SUNDRY NOTICES AND REPORTS ON WELLS (DO NOT USE THIS FORM FOR PROPOSALS TO DRILL OR TO DEEPEN OR PLUG BACK TO A DIFFERENT RESERVOIR. USE "APPLICATION FOR PERMIT" (FORM C-101) FOR SUCH PROPOSALS.)		WELL API NO. 30-015-20172
1. Type of Well: Oil Well ☒ Gas Well ☐ Other ☐		5. Indicate Type of Lease STATE ☒ FEE ☐
2. Name of Operator MOMENTUM OPERATING CO., INC.		6. State Oil & Gas Lease No.
3. Address of Operator P O BOX 2439 ALBANY, TX 76430		7. Lease Name or Unit Agreement Name GULF
4. Well Location Unit Letter 990 : feet from the NORTH line and 330 feet from the EAST line Section 28 Township 18S Range 31E NMPM EDDY County		8. Well Number 1
11. Elevation (Show whether DR, RKB, RT, GR, etc.) 3634 GL		9. OGRID Number 020451
		10. Pool name or Wildcat SHUGART Y-SR-OU-GB

Momentum Operating Gulf #1

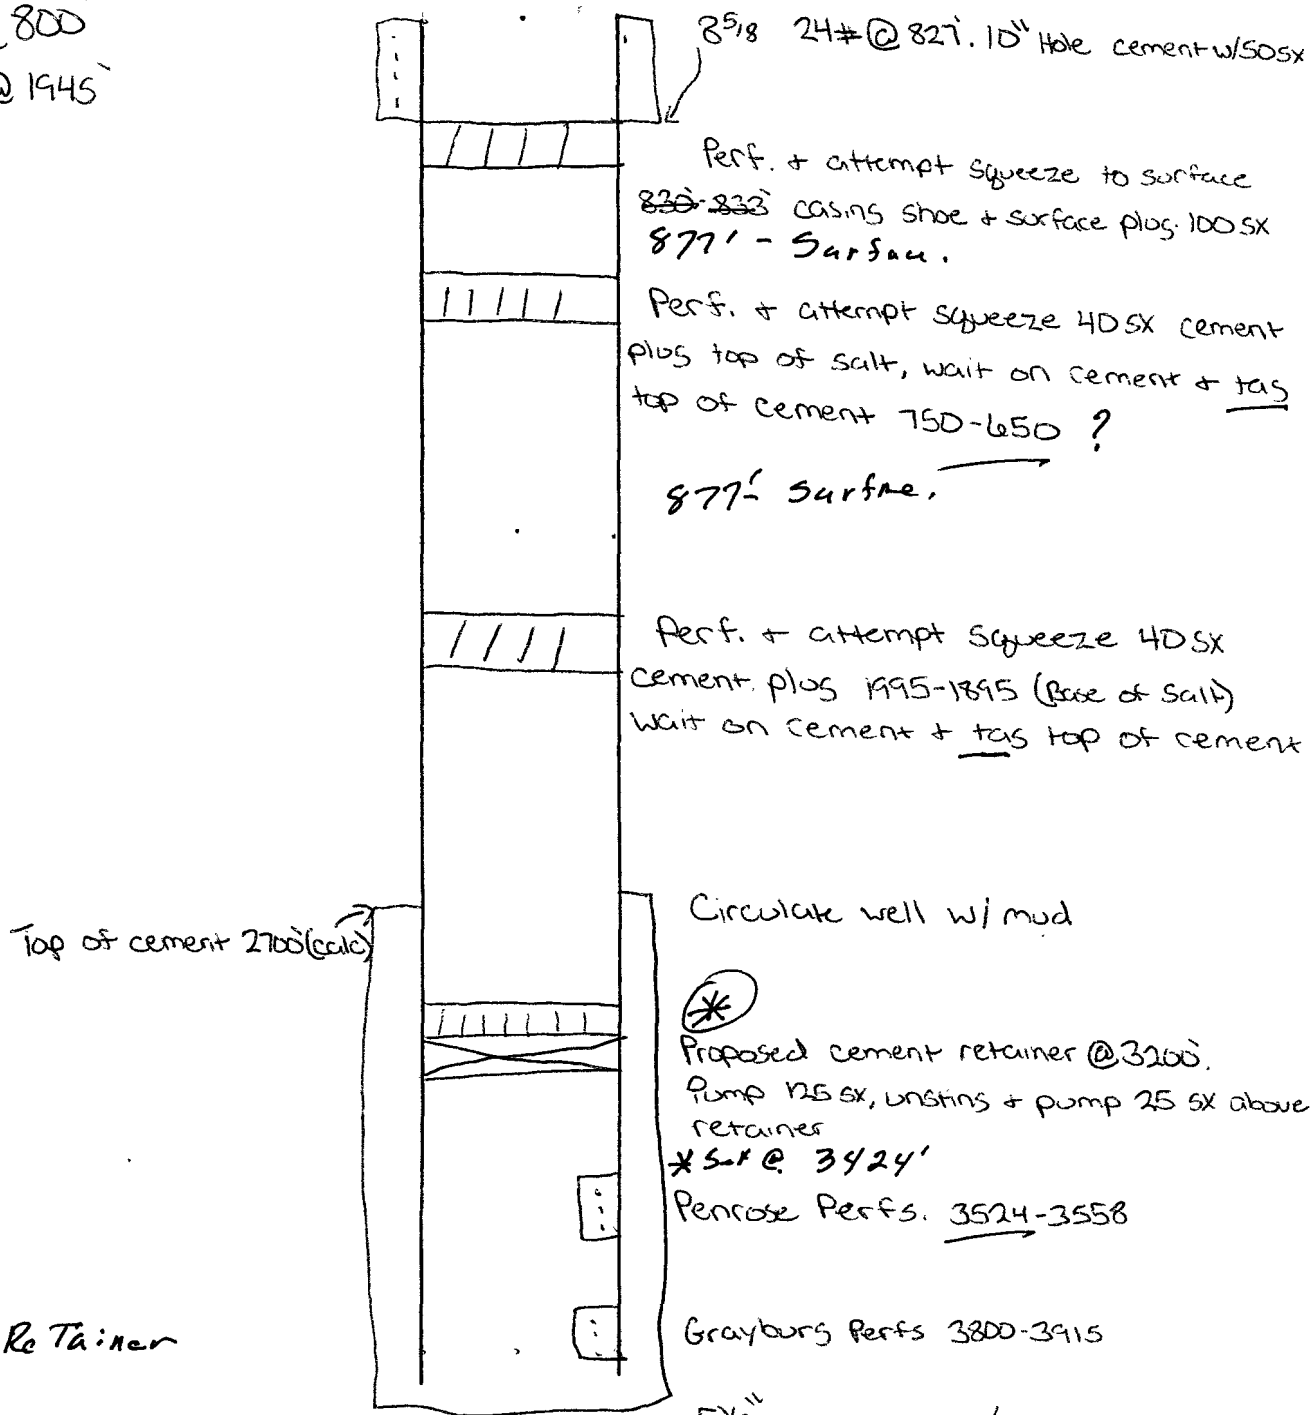
No Cement Retainer

* AC/BP w/ 35' CMT on Top
or a 100' CMT plug must be placed
within 100' of Top Perforation.
CMT Plug has to be Tagged
